Subject: Revision to Application to Reinstate the Provision for Loose Fuel Rods to be Shipped in the RA-3 Packaging

- References:
- (1) NRC Certificate of Compliance (COC) USA/4986/AF  
Docket Number 71-4986
  - (2) COC 4986, Revision 35, 4/2/98
  - (3) RA-3 Package Application Submittals Dated 6/5/98 and 6/25/98

Explanation of Changes by Page

## CRITICALITY SAFETY EVALUATION RA-3 FUEL BUNDLE CONTENTS

Figure 5c Maximum allowed number of damaged packages,  $2N$ , with product container contents

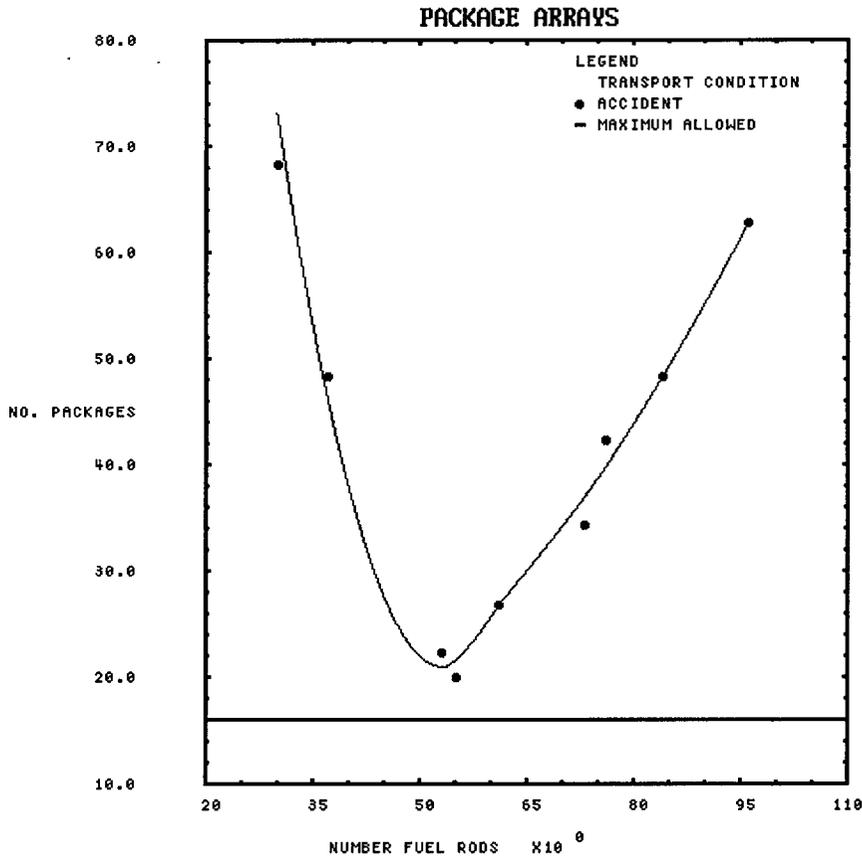
Page 1	Changed the N value to 8 and the TI to 6.3.
Pages 22, 23, 24 and 25	Starting with case ra10 - s6, we renumbered the cases and provided additional information to describe optimal fuel rod pitch.
Page 26	Replotted Figure 5c and limited the maximum allowed to $2N = 16$ .
Page 27	Corrected reference from Criticality Index to Transportation Index and reflected the revised number of maximum packages per shipment.

Each value for  $2N$  is plotted versus the number of fuel rods that corresponds to the value determined for a specific array size as shown in Figure 5b. This demonstrates that there is a maximum number of packages allowed for which the damaged array is subcritical independent of the number of fuel rods loaded in the product container. This maximum allowed value for  $2N$  shall be no less than 16 as shown in Figure 5c.

Under hypothetical accident conditions, an infinite number of packages with a bundle of 20 fuel rods loaded directly in the channel assembly is subcritical. Therefore, 2N is equal to infinity when the product container is not used. A maximum of only 16 damaged packages remain subcritical when the product container is used, and 2N is equal to 16 when the product container is used.
